ECE/TRANS/WP.11/2007/14 31 August 2007

Working Party on the Transport of Perishable Foodstuffs

PROPOSED AMENDMENTS TO THE ATP

Annex 1, Appendix 3, ATP model certificate

Standard ATP model certificate model, see pages 3 and 4.

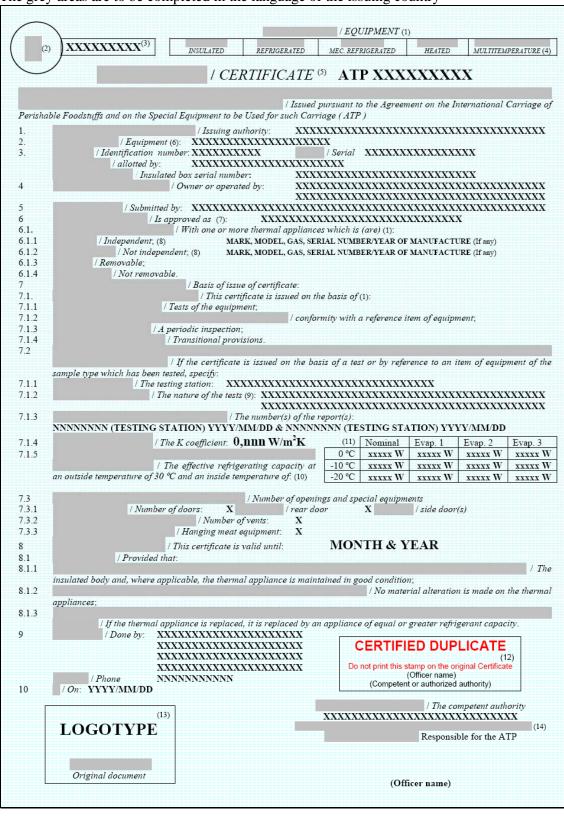
The ATP model certificate is shown in Annex 1, Appendix 3 A. In spite of this, there is no uniformity in ATP certificates delivered by different competent authorities. Totally different certificates can be found, with one single page, two pages or even three pages and some of them without any security system to prevent copy or forgeries.

In order to reach greater uniformity and safety, and taking into account the results achieved at the 62nd session with document ECE/TRANS/WP.11/2006/1 (Report of the Informal Working Group on Securing Documents), and suggestions made by several delegations, Portugal proposes a new revised standard ATP model certificate be adopted to substitute the existing one.

The grey areas are to be completed in the language of the issuing country

/ To be printed on the rear of the ATP certificate
The areas in must be replaced by the translation in the language of the country issuing the ATP certificate.
